■ ■ ■ - ■ ■ ■
Service Bulletin No. 49

Model: TA-4650, -5650

Subject: V-FET Replacement

Subject: V-FET Replacement

2SJ18, 2SK60

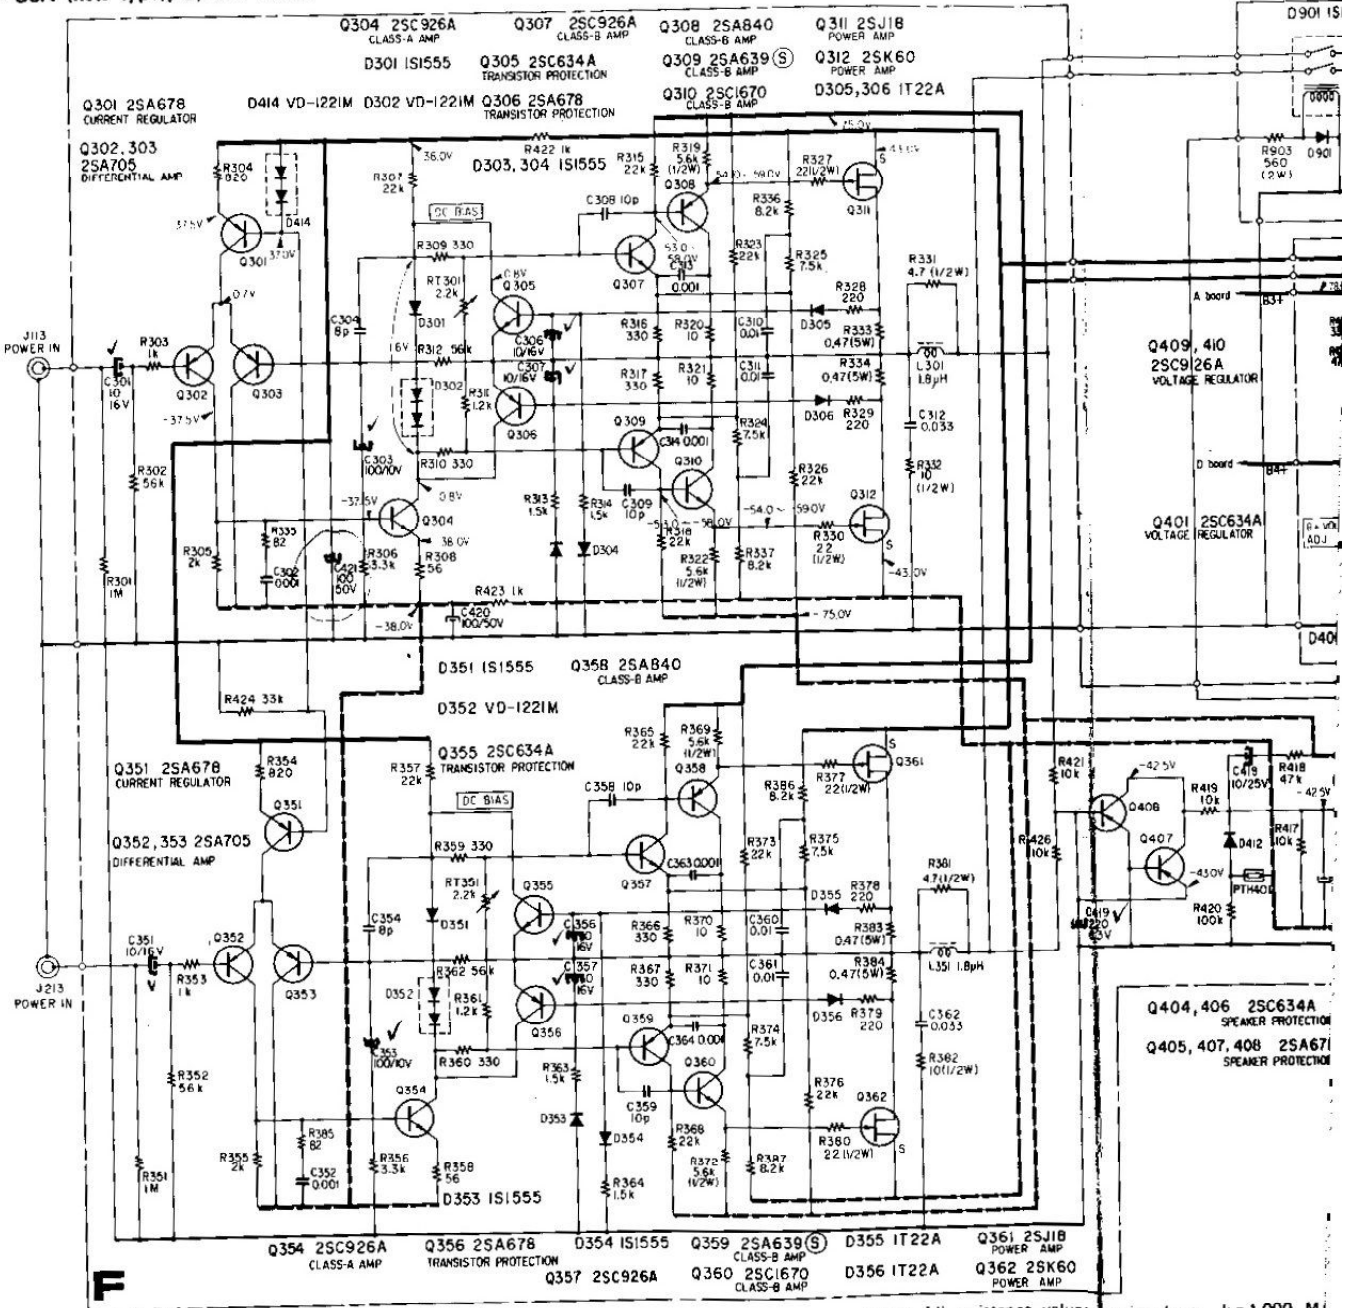
Perform the following procedure if V-FET failure is suspected. To avoid damage to a replacement V-FET, do not replace without first making this check.

1. Turn off the power and remove the suspect V-FET.
2. Check resistance readings of this V-FET using a VOM set to the $X1\Omega$ range. See illustration below.

S to D ----- Approx. $1\sim 2\Omega$

S to G ----- Same as a diode

D to G ----- Same as a diode

If readings appear normal, the V-FET is probably okay, and other circuit components should be checked.

3. If readings are not normal, turn on the power with the V-FET still out of the circuit. Set the VOM to the 50 VDC range (or as close as possible) and connect the leads to the V-FET conductor patterns on the board as follows:

4. Set the dc bias adjust resistor (see below) on the Power Amp Board for maximum reading.

5. Turn off the power and install the replacement V-FET. Reapply power and reset the dc bias according to the service manual for the respective model.
